## BIDDING ADDENDUM 1

For work titled:  
Acee's Neighborhood Market & Deli  
1000 Holiday Lane  
Fulton, KY 42041  
Project Number: 23-7038

## Request for Information

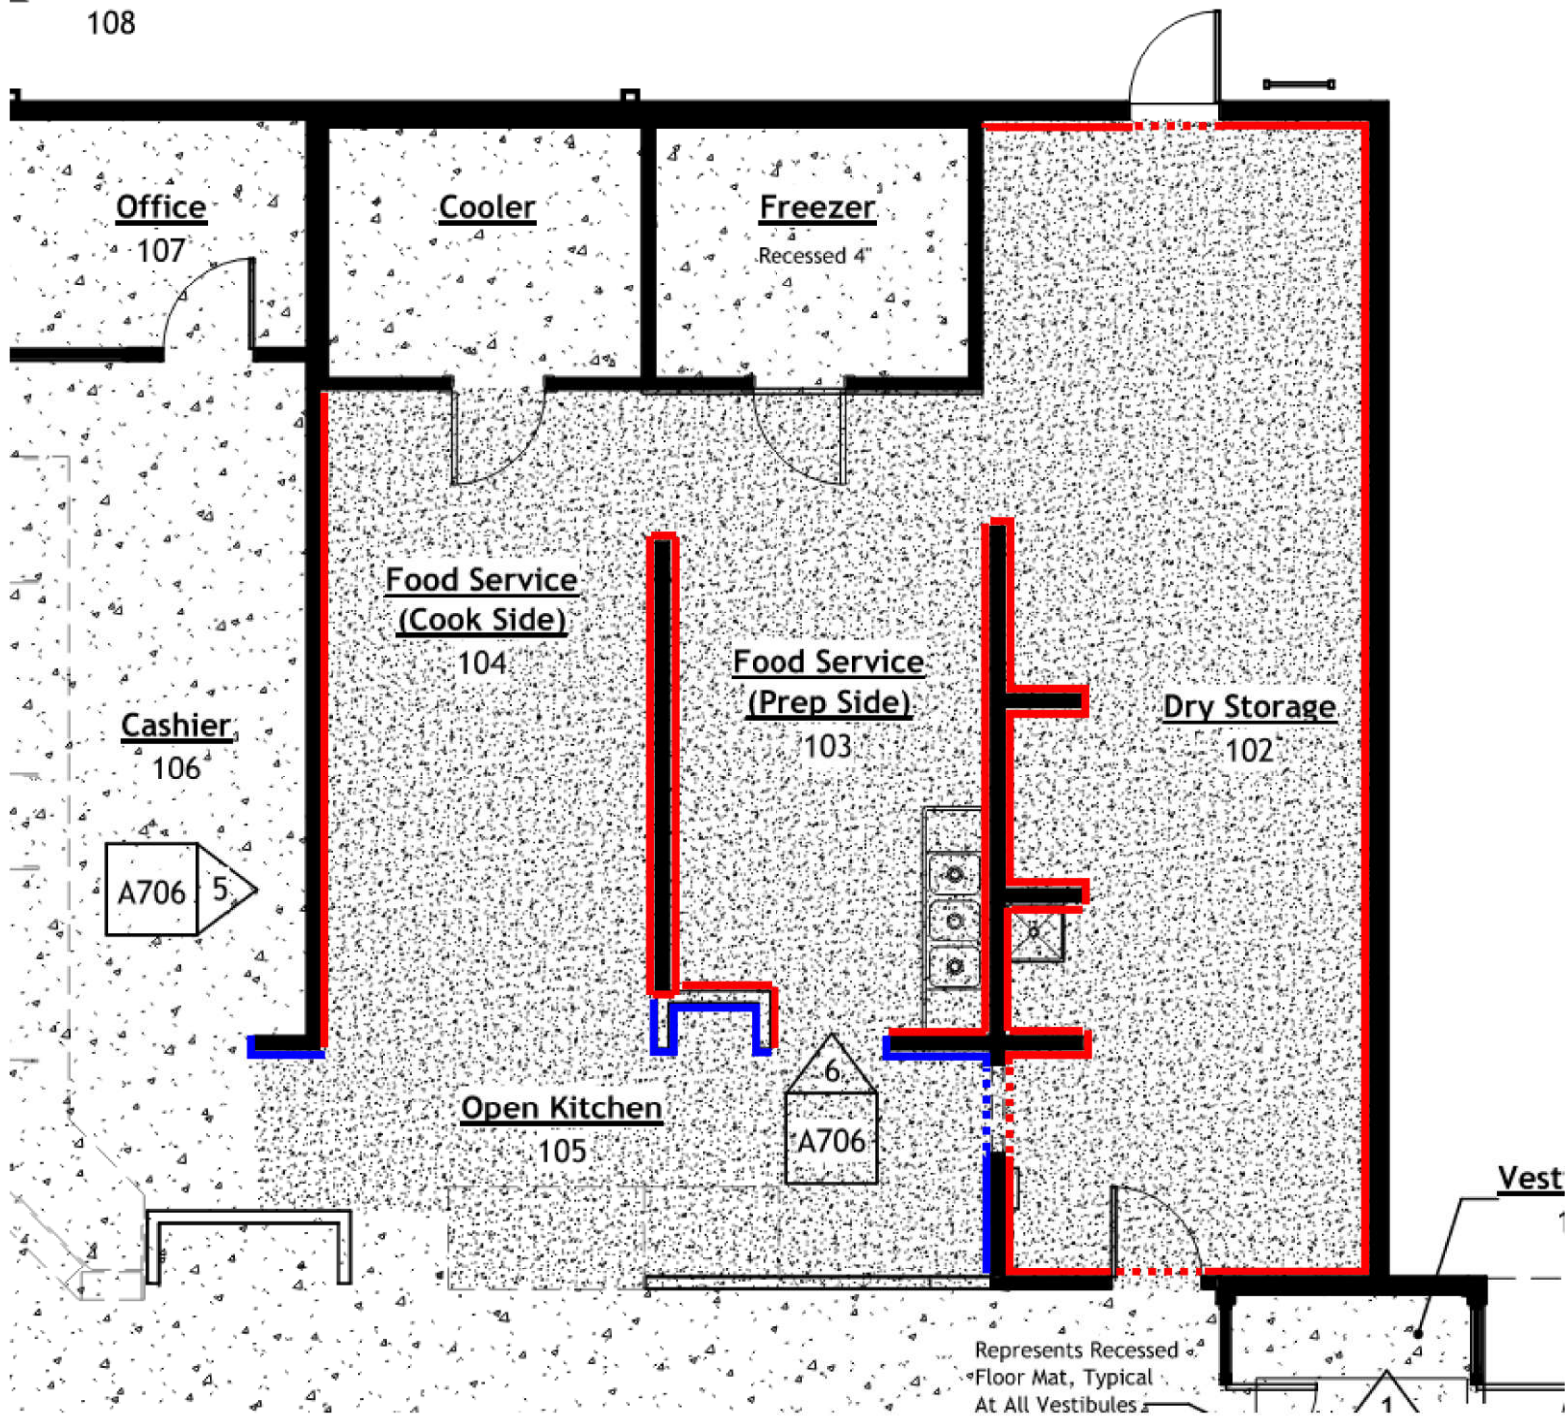
4. Detail 3 on A509. We must have a minimum of 10" base flashing above the finish roof height. The stone can not run down to roof as shown. [Stone only needs to extend below lowest parapet \(approx. 6"\) so visible portions of high parapets are covered in stone.](#)

10" min. between bottom of stone and top of roof. Stone only needs to extend below lowest parapet (approx. 6") so visible portions of high parapets are covered in stone.
